Re: Relocation of Truck Dump and Culverts  
Savage Service Corporation  
Savage Coal Terminal  
C/007/022 , Task #3892

Enclosed are 3 copies of a revised amendment to the Savage Coal Terminal MRP. The amendment is being resubmitted to show the relocation of a former temporary truck dump and to update the hydrology map to show the existing culverts, per the request in your letter of August 31, 2011. The Culvert Design Table 7-25 and the Refuse Pile Drainage Table 7-26 have also been revised to reflect present conditions.

**Title:** Relocation of Truck Dump and Culverts

SAVAGE COAL TERMINAL FACILITY MAP

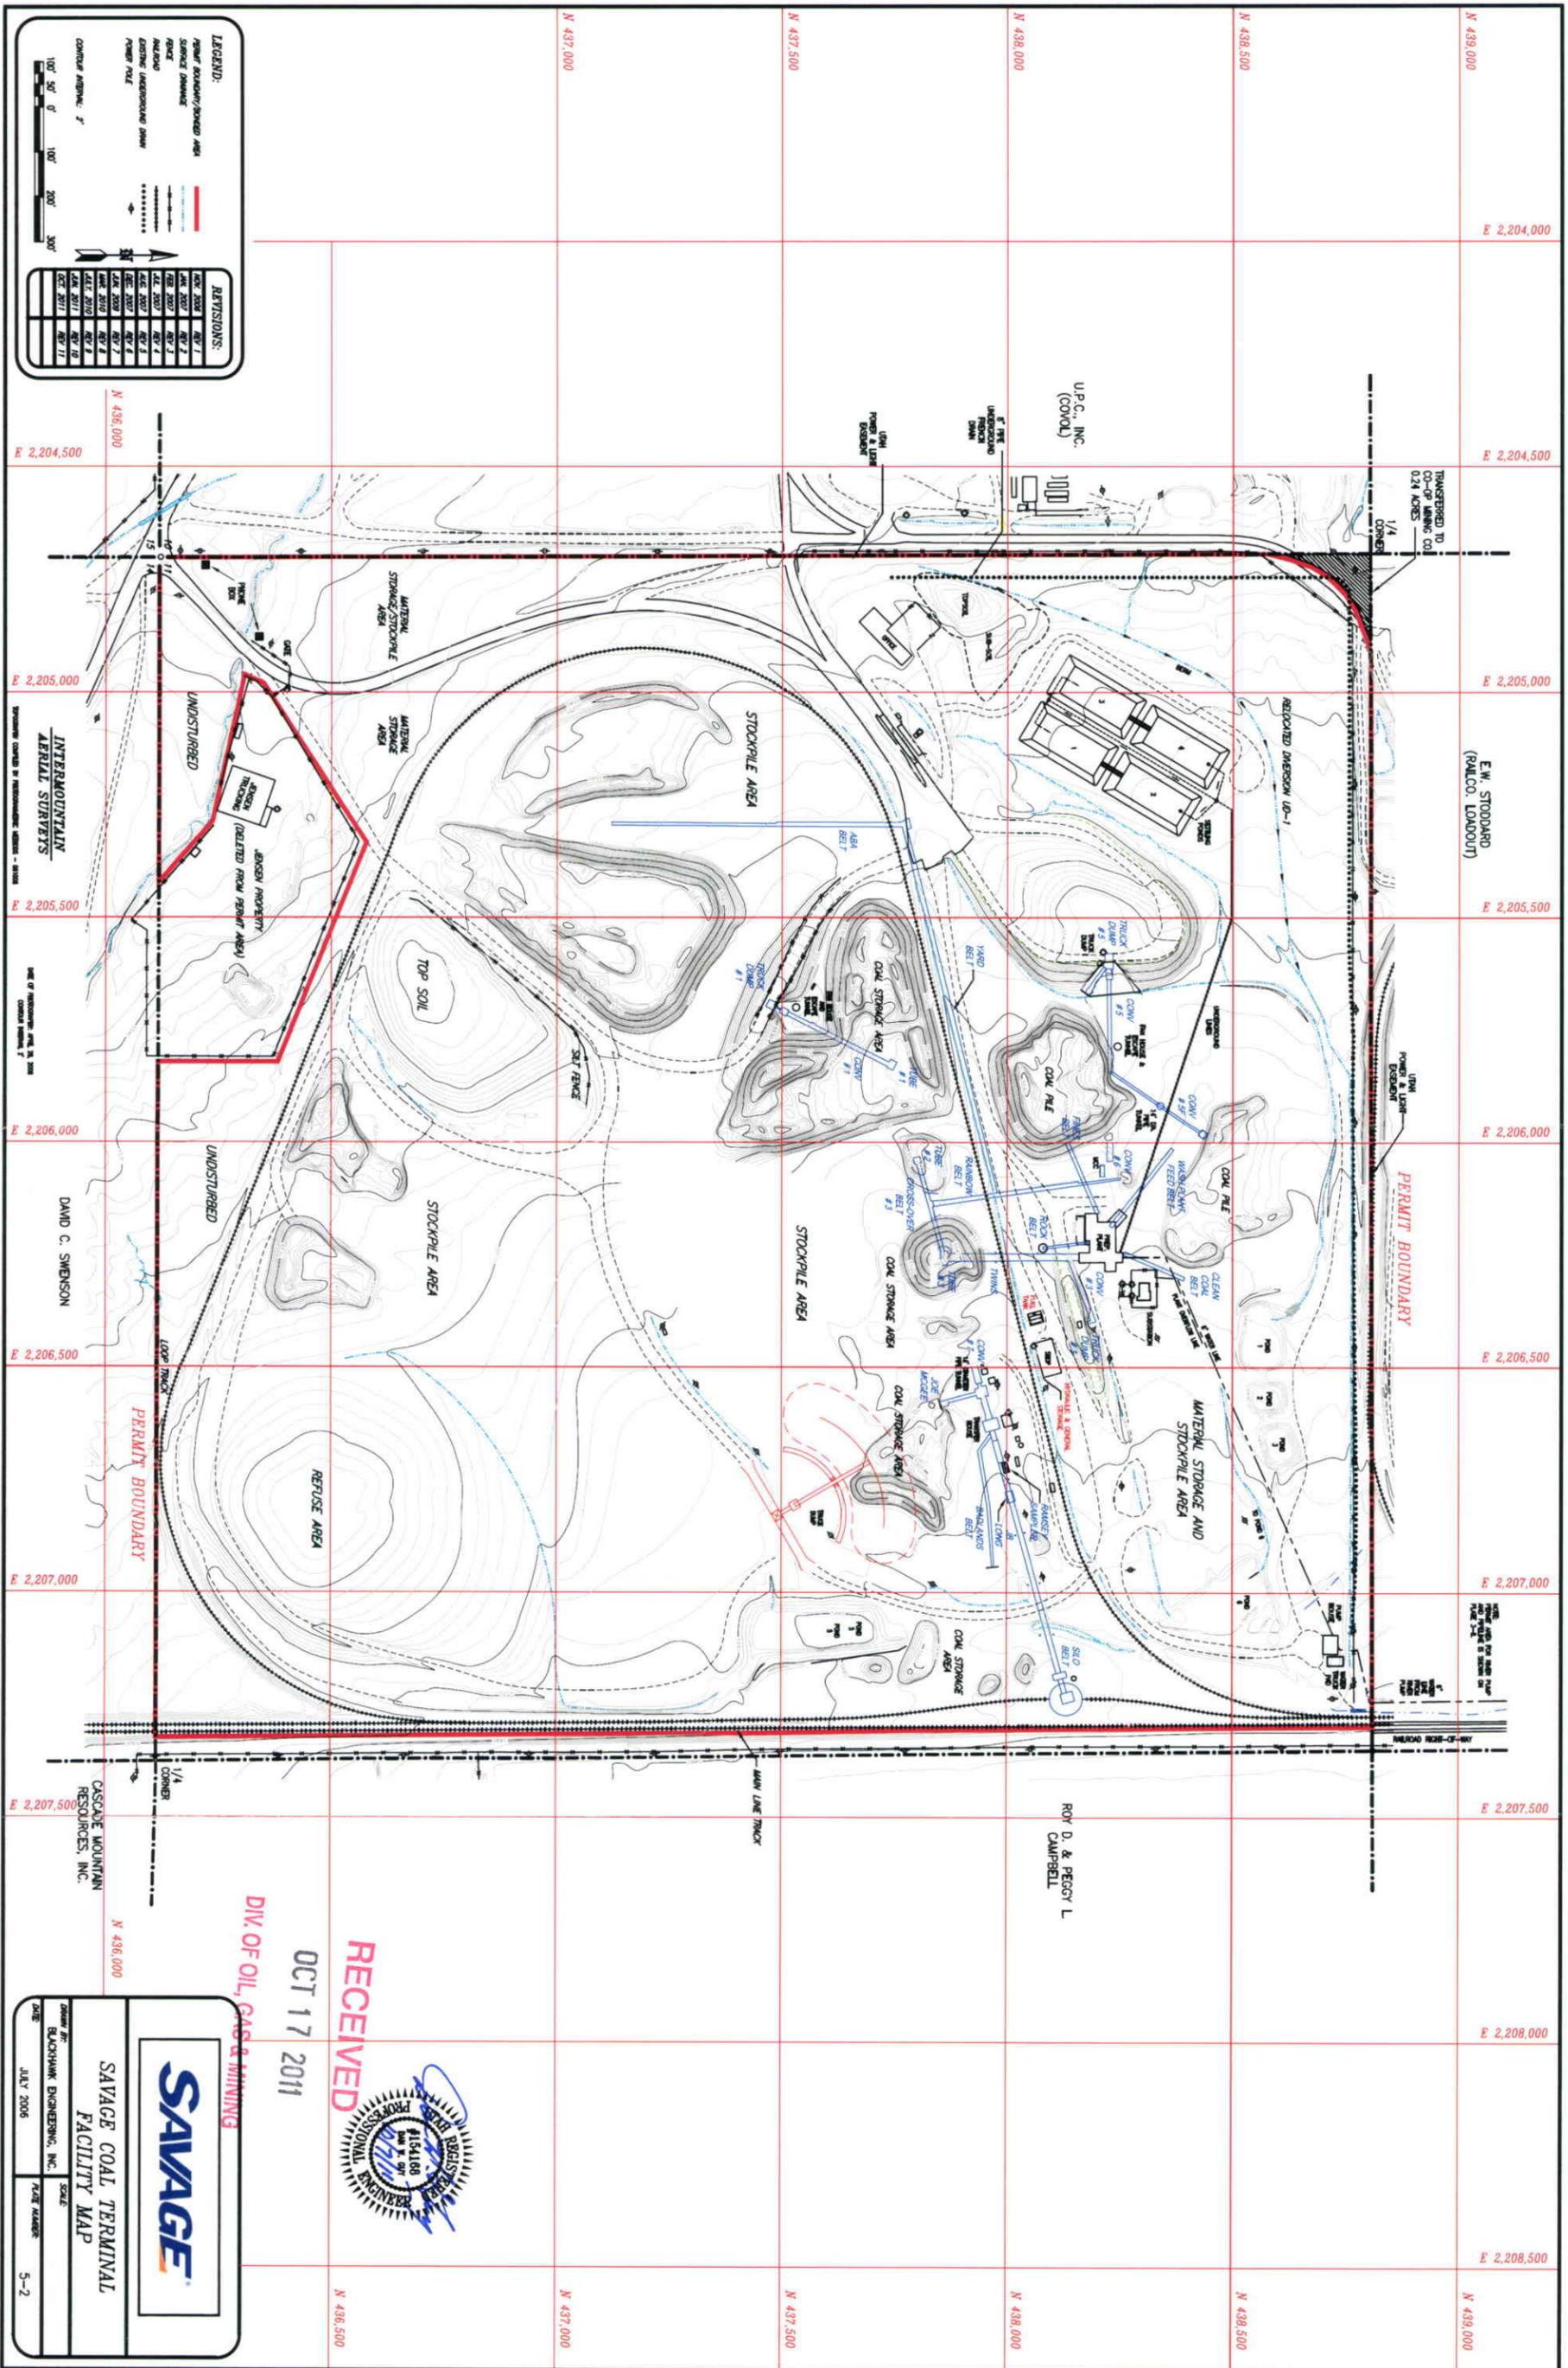
Updated Plates 5-2, 7-2, and Tables 7-25 and 7-26 are included, along with required C1/C2 Forms. If you have any questions, or need additional information, please let me know.
